PJM Tier I Inventory & Forecasting

*Updates to Eligible Supply, Capacity Factors, and Addition Assumptions
in response to PRRP RPS Study Group report by Exeter Associates*

June 8, 2018

MDV-SEIA

Figure IV-1. Non-carve-out Tier 1 Generation Required by the RPS in Maryland and PJM

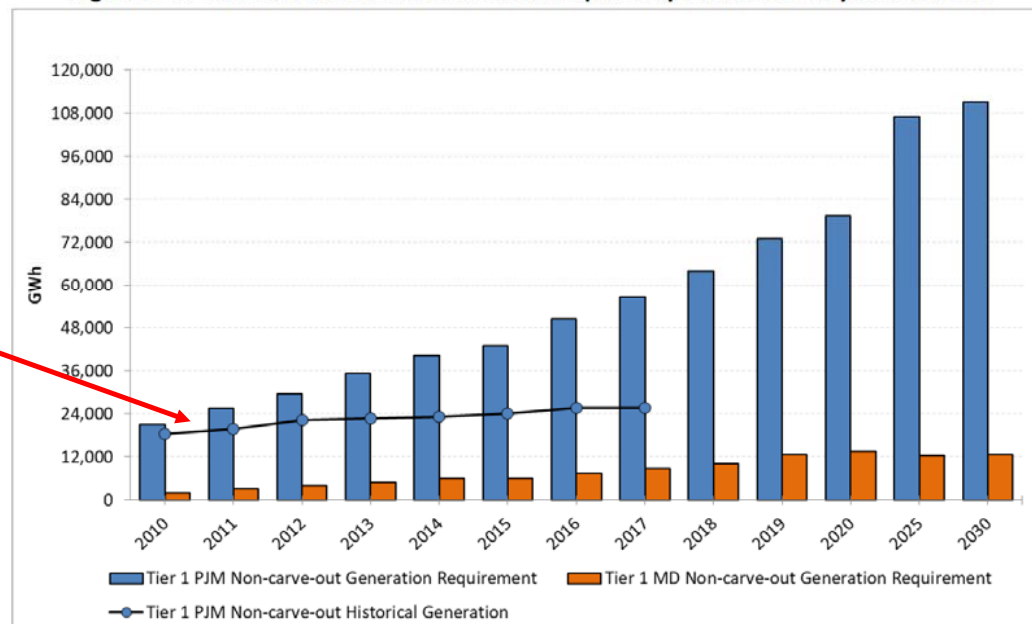
- Figure IV-1 from the Exeter report shows that the Tier I PJM Non-carve-out Historical Generation (in GWh) is well below the Tier I PJM Non-carve-out Generation Requirement. This represents an “undersupplied” market that would be trading close to ACP levels.

This line represents Exeter’s estimate of Tier 1 supply (i.e. Exeter’s “Tier 1 Inventory”).

According to this estimate, Tier 1 demand (shown by the blue bars) far exceeds supply, and PJM Tier 1 RECs are under-supplied.

Comparison of Exeter's Generator Summation vs PJM-wide Tier I Eligible Generators

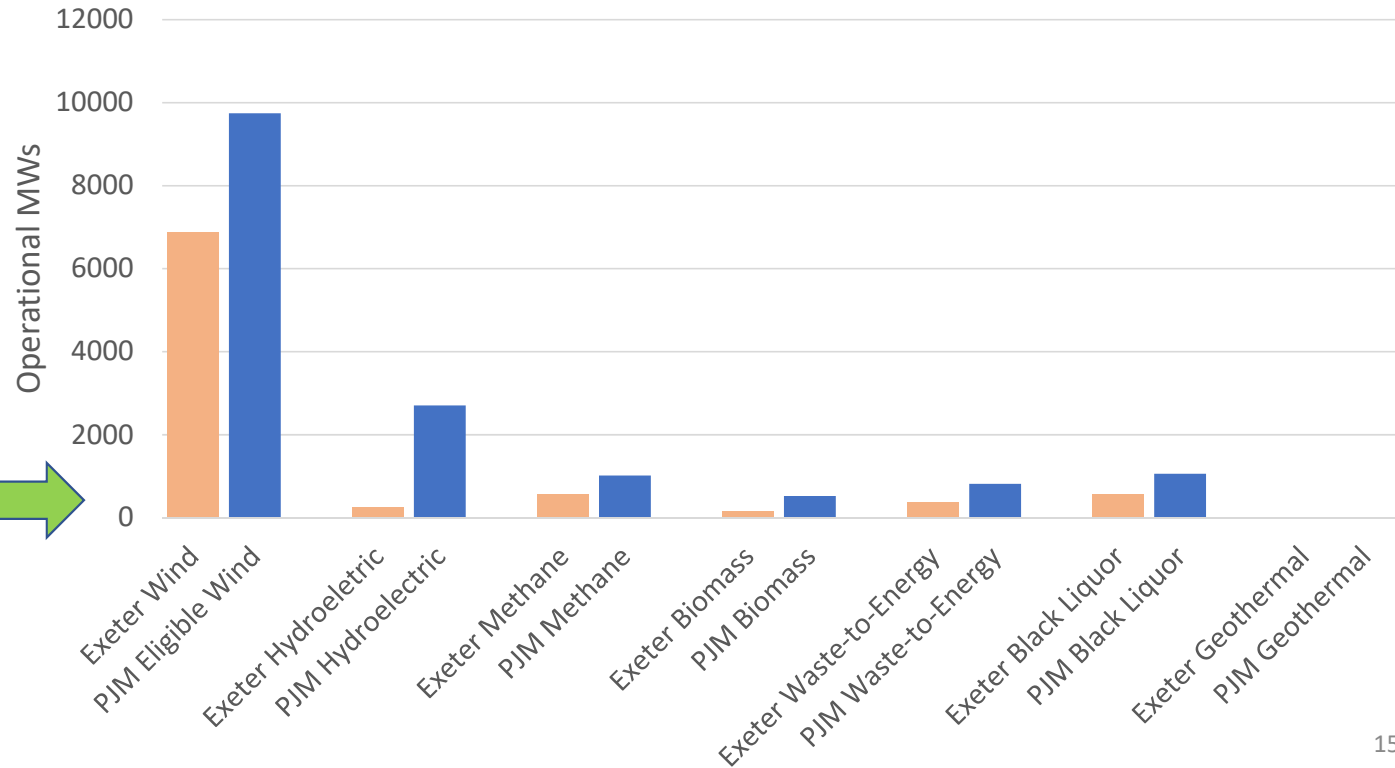
- The Exeter approach did not include all Tier I eligible generators, but rather only those that registered in MD. This results in an under-estimate of Tier 1 supply that is eligible for the Maryland RPS.

- By applying Maryland RPS eligibility criteria to all PJM resources, the Exeter approach failed to account for this fungibility dynamic. This contributes to Exeter's under-estimate of Tier 1 supply.

Tier 1 Inventory: Result of MDV-SEIA Analysis

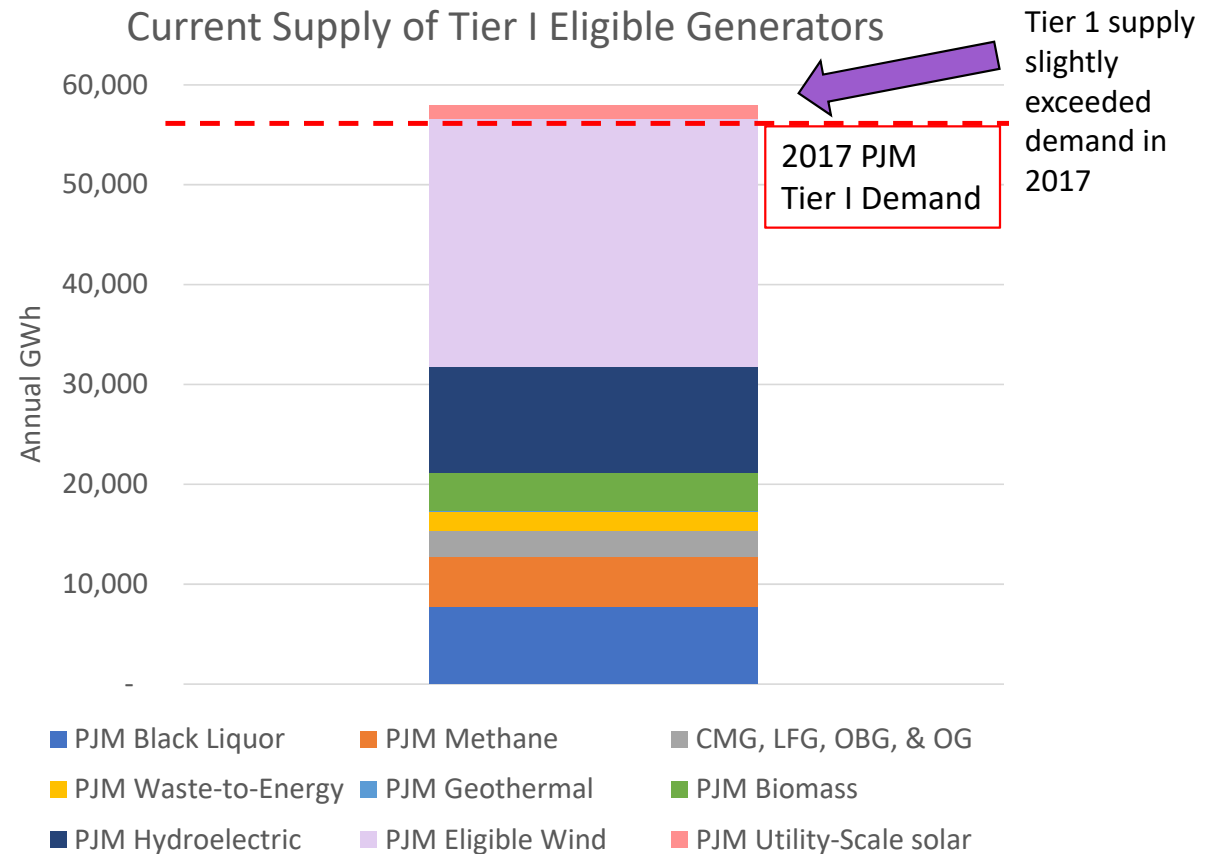
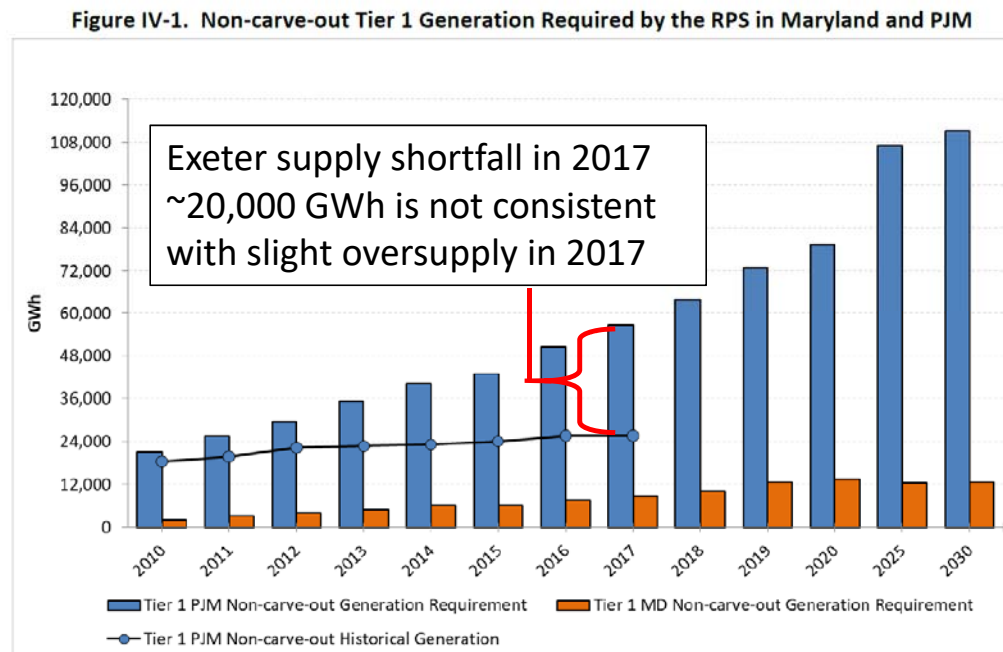
- Using Exeter's aggregate RPS demand tabulation:
 - 2017 PJM Tier I demand: **55,650 GWh**
- MDV-SEIA's PJM Tier 1 inventory methodology estimates slight oversupply in PJM in 2017
- This is consistent with stable PJM Tier 1 prices in 2017 in the \$6-\$12/MWh range vs. ACPs in the \$30+ range
- This observation is inconsistent with Exeter's under-supply estimates which show significant undersupply in 2017

Addition Rate Assumptions - Wind

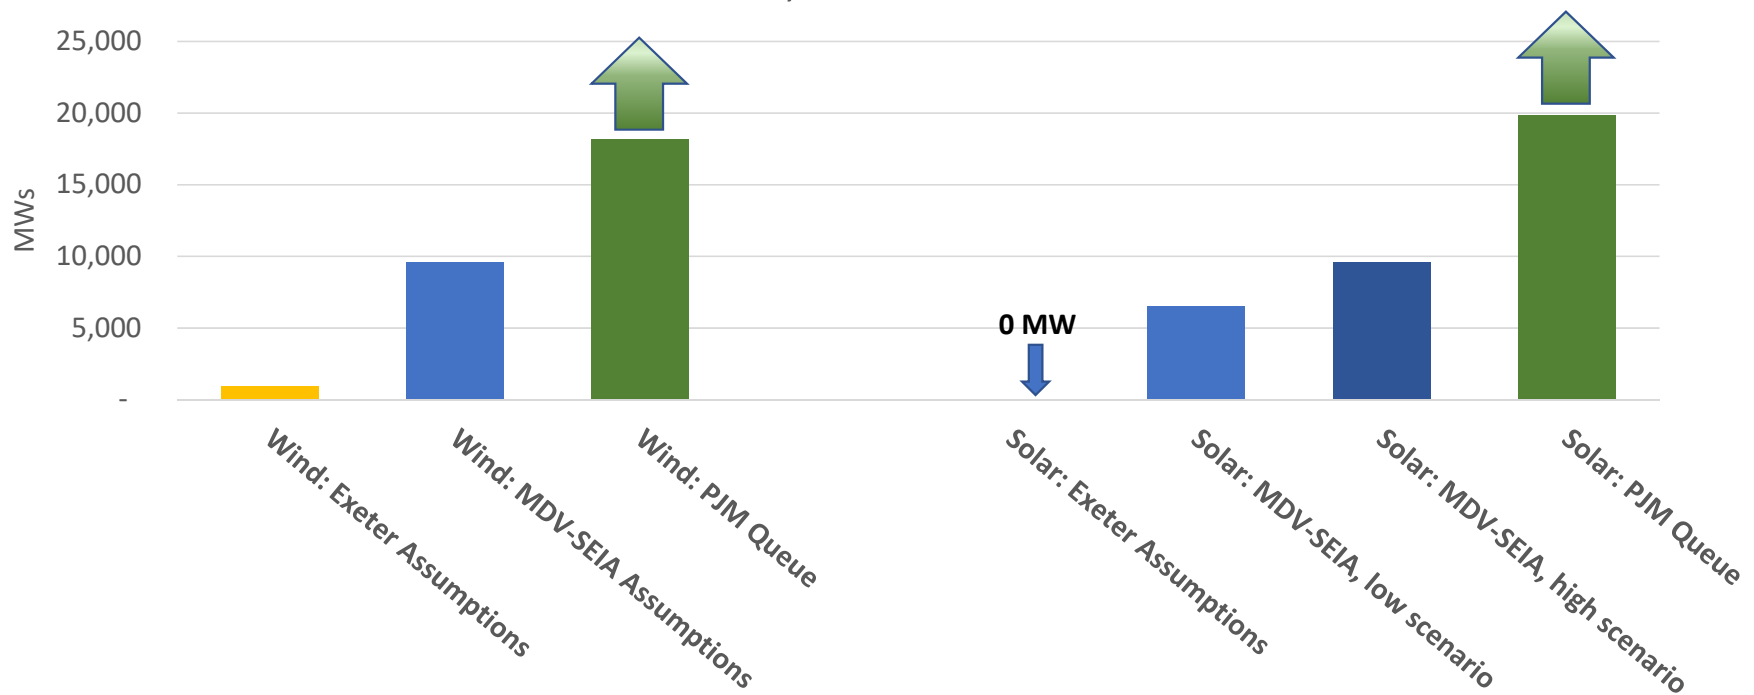
- Exeter's analysis assumed 940 MW of total wind additions from 2018-2030 (or **78 MW/year**)
- Historic additions over the last 10 years have been roughly **800 MW/y** year in PJM
- The PJM queue for wind projects under development currently shows ~18,000 MW of wind projects under study, engineering, or construction in PJM
- It is reasonable to assume that there will be a continued addition rate of 800 MW/y of PJM Tier I eligible wind over the next decade

Addition Assumptions: PJM Tier I Eligible Wind and Utility-Scale Solar, 2018-2030

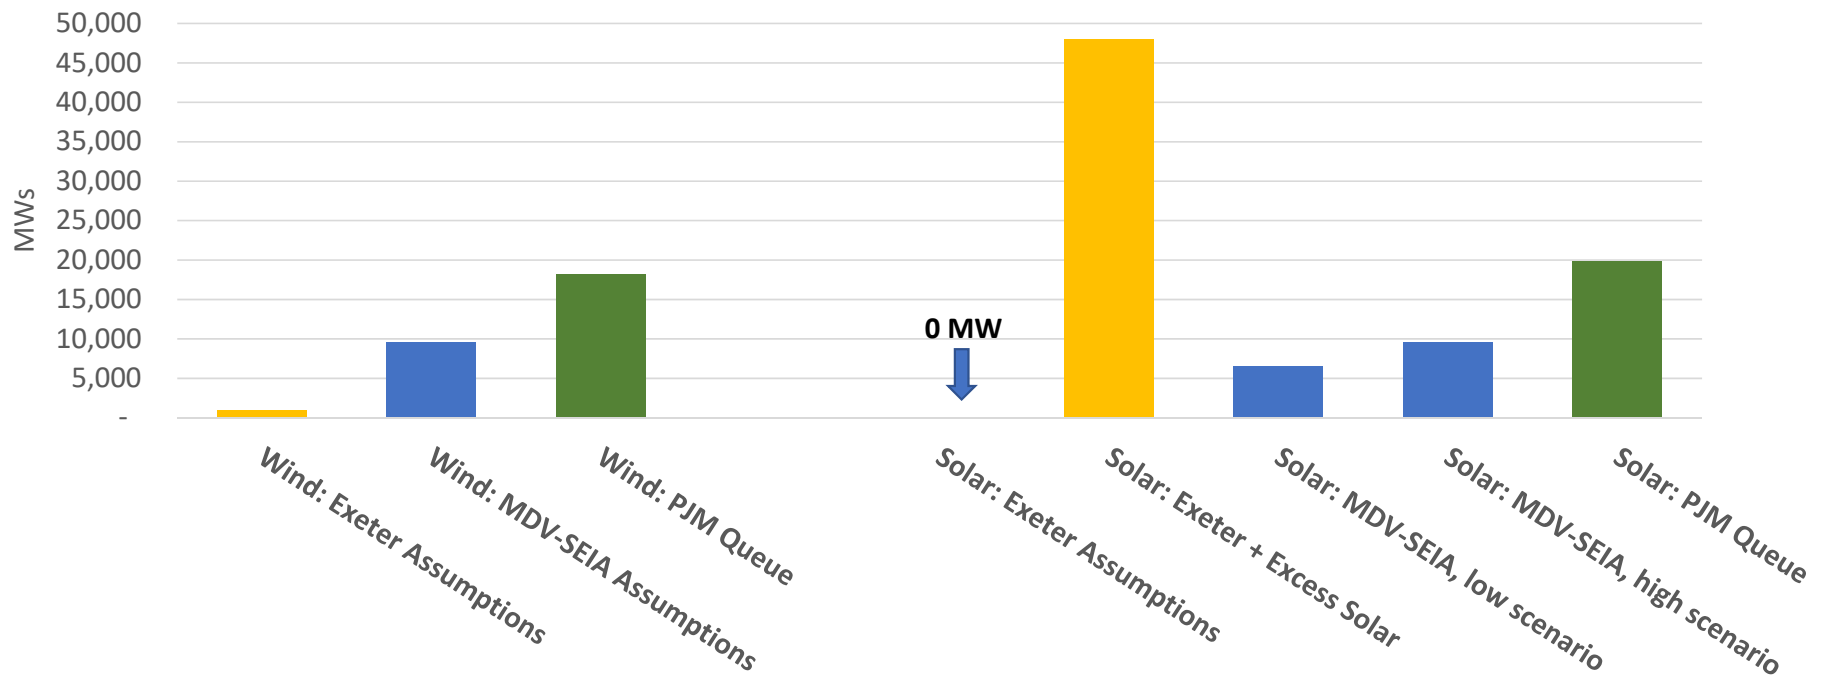
- Exeter's solar additions are assumed to fulfill RPS carve-out demand and **0 MW** of utility-scale solar additions to serve Tier I non-carve-out demand

For Undersupply Narrative to Hold, Expected Tier 1 Solar Additions Must Be Ignored
